Summary Document for Replication of USBR Rule of Thumb Curve for Shasta Storage and CCR Temperature
 Prepared by the Southwest Fisheries Science Center on December 7th, 2016

Goal: Estimate relationship between Shasta Reservoir storage, cold pool storage, and Clear Creek gage (CCR) water temperature and compare to USBR estimates. Note his analysis is referred to as ‘NOAA analysis’ in this document.

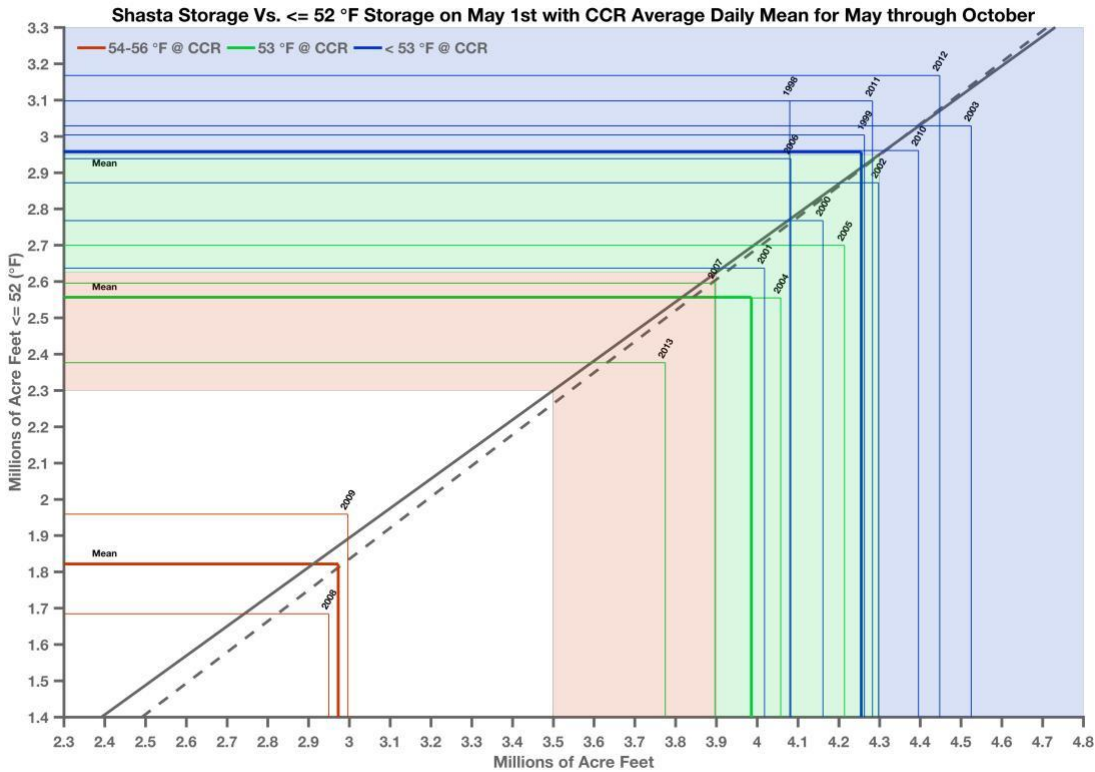
- USBR estimates do not align with NOAA estimates calculated from CDEC and USBR profile data under given assumptions. To resolve, some descriptions of the methods and data used to produce USBR estimate are needed.
- Trend between USBR and NOAA estimates are consistent that greater total/cold pool storage are associated with colder average temperatures at CCR (linear models between cold pool and storage relationship are also similar with USBR estimate slight biased upwards).
- USBR estimates indicates no overlap between CCR temperature criteria and total/cold pool storage while NOAA estimates indicates some overlap (especially under average daily maximum method), more clearly indicating other factors associated with CCR temperatures aside from May 1st total/cold pool storage.
